**Providence City
Administrative Land Use Authority
Agenda – Thursday, April 25, 2019 10:30 AM
Providence City Office Building
164 North Gateway Drive, Providence UT 84332**

Item No. 1. Conditional Use – Site Plan: The Providence City Administrative Land Use Authority will consider for approval a request by Adam Sorenson for approval of a conditional use site plan for a single-family residence located at 379 N Sarah Street, Providence UT.

Item No. 2. Conditional Use – Site Plan: The Providence City Administrative Land Use Authority will consider for approval a request by Nathan and Sannette Webb for approval of a conditional use site plan for a pool located at 600 Hillsborough Drive, Providence UT.

RE: 379 North Sarah Street, Providence UT

SITE PLAN
SCALE: 1" = 20'

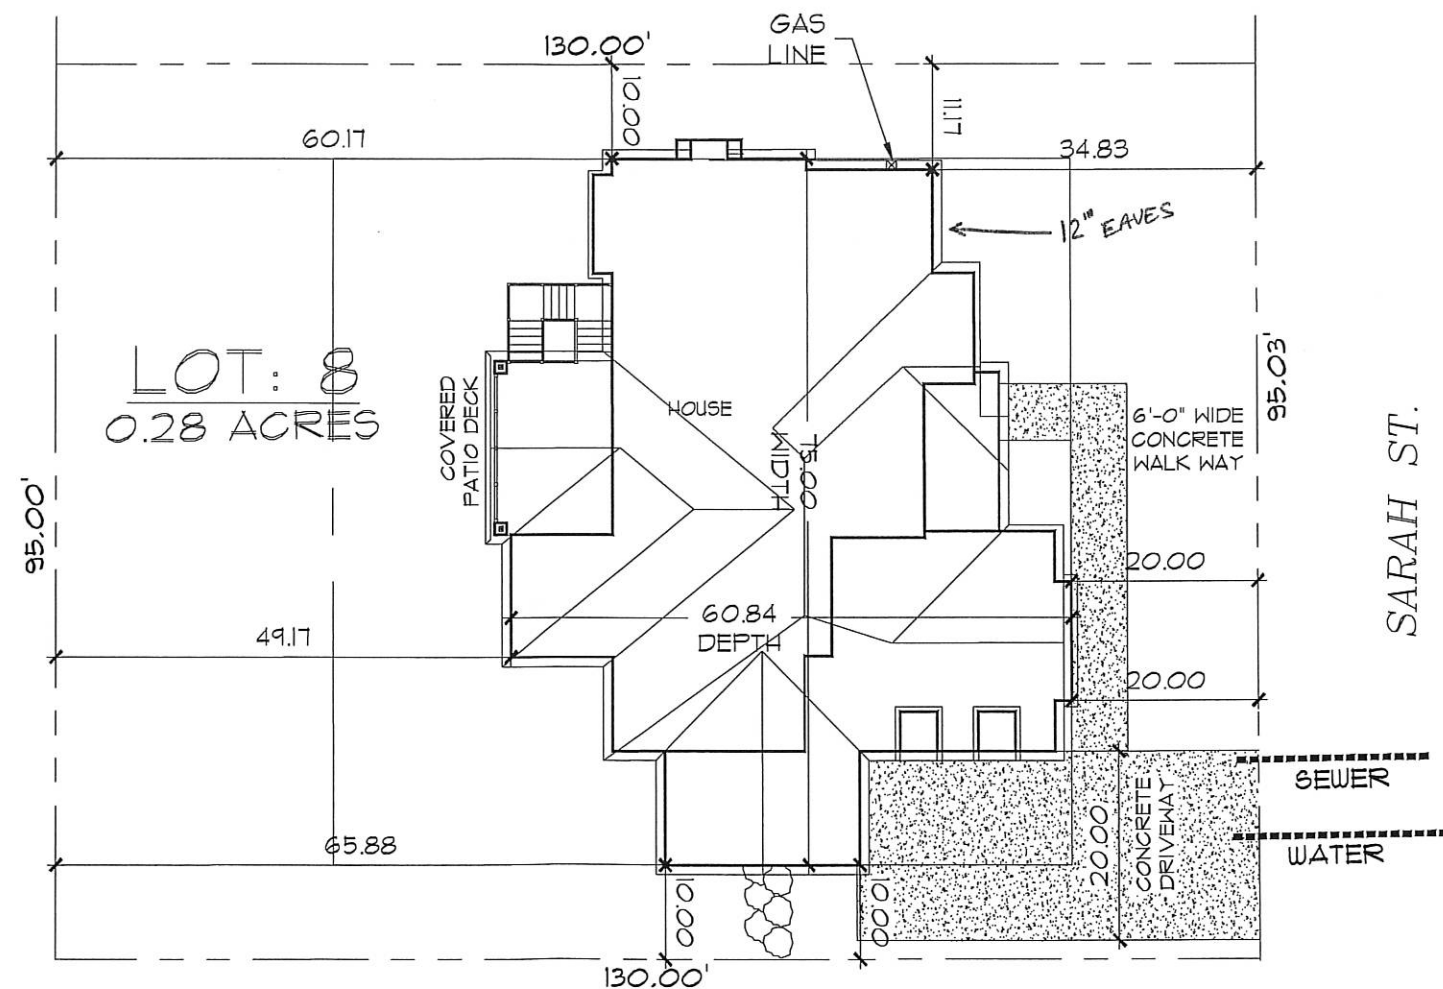
- **The building appears to be approximately 5,263 square feet in size. According to Table B105.1 the fire flow for a combined fire area 5,263 sq. ft. of type V-B is 2,000 GPM. Fire Flow requirements are subject to change due to separation of fire areas, type of construction, and the installation of fire suppression system.**
- **There are two hydrants within 600 feet of the structure**
- **Hydrant #507 has approximately 2,242 GPM at 20 PSI and is adequate for this size of construction.**

*506.2 Roof covering. Roofs shall have at least a Class A covering, Class C roof assembly or an approved noncombustible roof covering. For roof coverings where the profile allows a space between the roof covering and roof decking, the space at the eave ends shall be fire-stopped to preclude entry of flames or embers. (No wood shakes or combustible roofing used) **Builder is planning on a Class A roof covering. Approved***

*506.3 Unenclosed under-floor protection. Buildings or structures shall have all under-floor areas enclosed to the ground with exterior walls. Exception: Complete enclosure may be omitted where the underside of all exposed floors and all exposed structural columns, beams and supporting walls are protected as required for exterior 1-hour fire-resistance-rated construction or heavy timber construction. (Per County Fire Marshal - Soffits to be installed as to close underside of combustible decks and supported structures) **Builder is planning on closing all underfloor decks and eaves with soffits. Approved.***

*506.4 Vents. Attic ventilation openings, soffit vents, foundation or under-floor vents or other ventilation openings in vertical exterior walls and vents through roofs shall not exceed 144 square inches each. Such vents shall be covered with noncombustible corrosion resistant mesh with openings not to exceed 1/8 inch. **Home owner is planning on installing 1/8" mesh screen on all openings. Approved***

This project is being recommended to Providence City for approval.

The Webb Residence
Scale: 1" = 30' (11"x17" page)

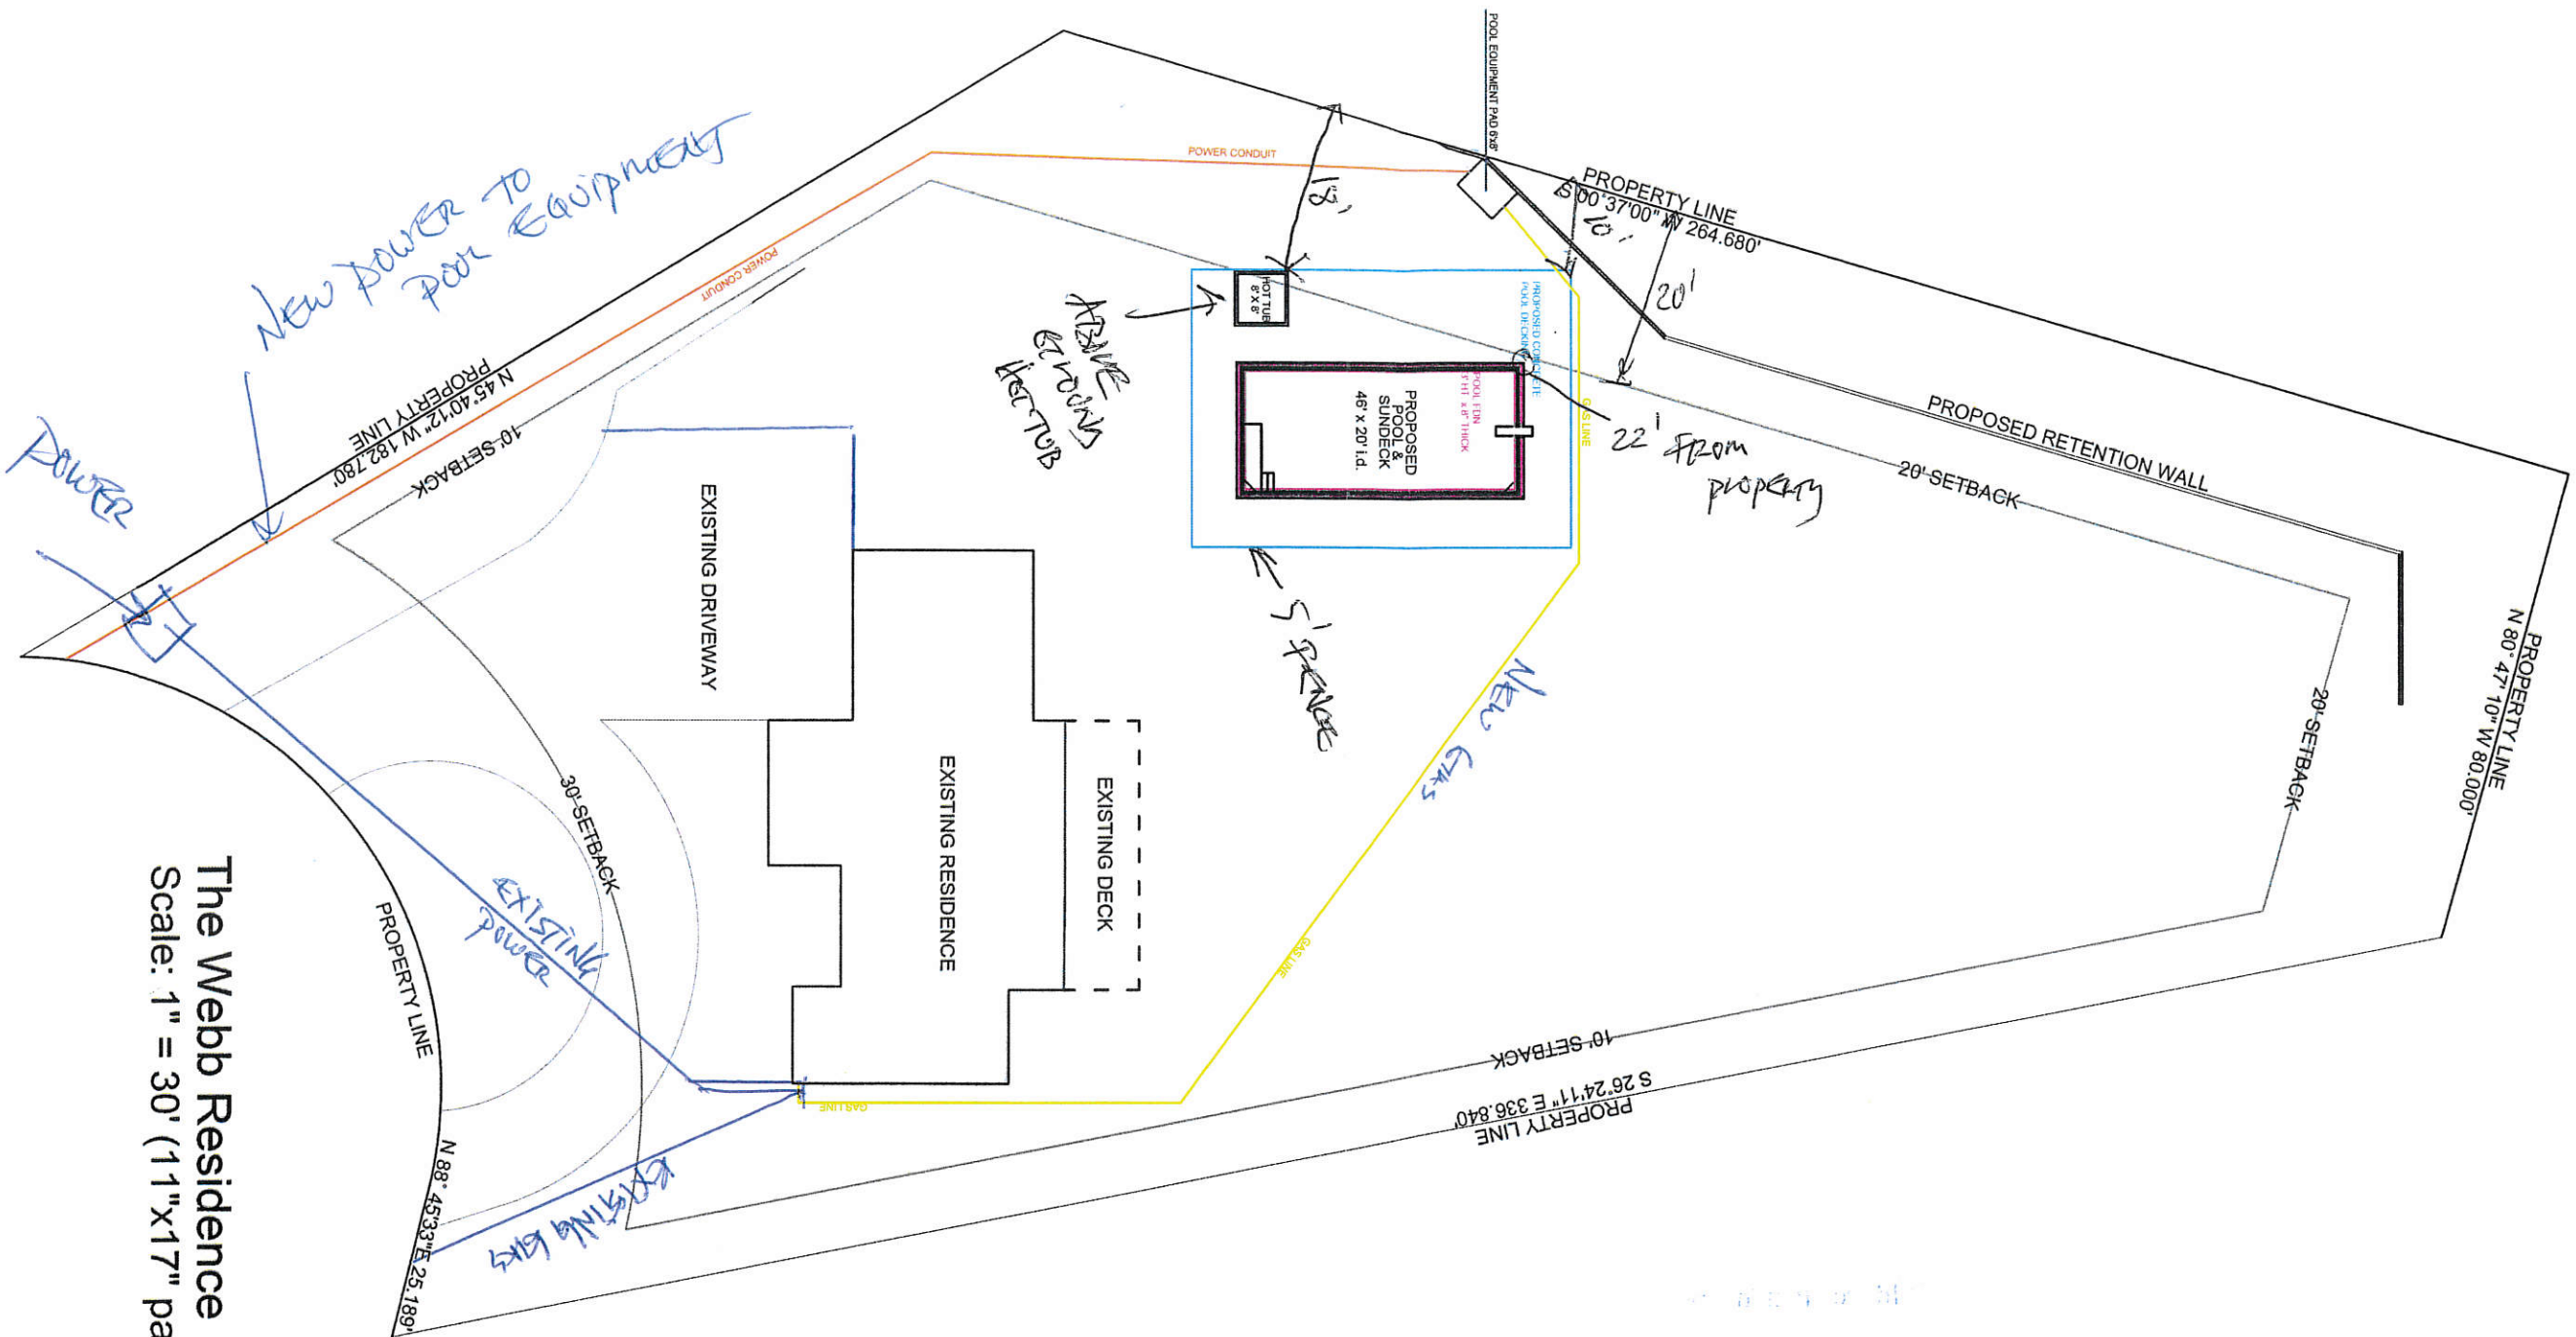
I really do not have any concerns with the proposed pool where it is just mostly concrete and a fence.

Building department will want to inspect the electrical and possibly the concrete for steel.
